Economic Commission for Europe**Inland Transport Committee****World Forum for Harmonization of Vehicle Regulations****Working Party on Noise and Tyres****Seventieth session**

UN Regulation No. 59 (Replacement silencing systems)**Proposal for the 03 series of amendments to UN Regulation
No. 59****Submitted by the expert Germany***

"UN Regulation No. 59

Uniform provisions concerning the approval of replacement silencing systems

Arrangements of approval marks

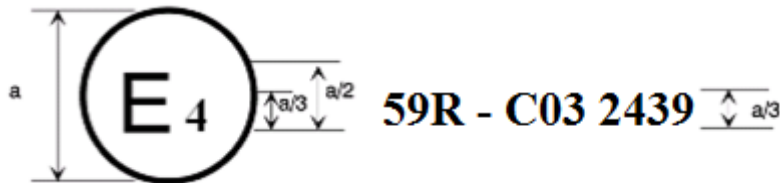
15. The example of the approval number and explanations are adapted to the 03 series of amendments.
-

The character C symbolizes that the approval was granted for the limit values according to phase 3 as given in paragraph 6.2.2. of the 03 series of amendments of the Regulation No. 51, followed by two digits of the approval number that indicate that the approval was granted in accordance with the requirements of Regulation No. 59 as amended by the 03 series of amendments.
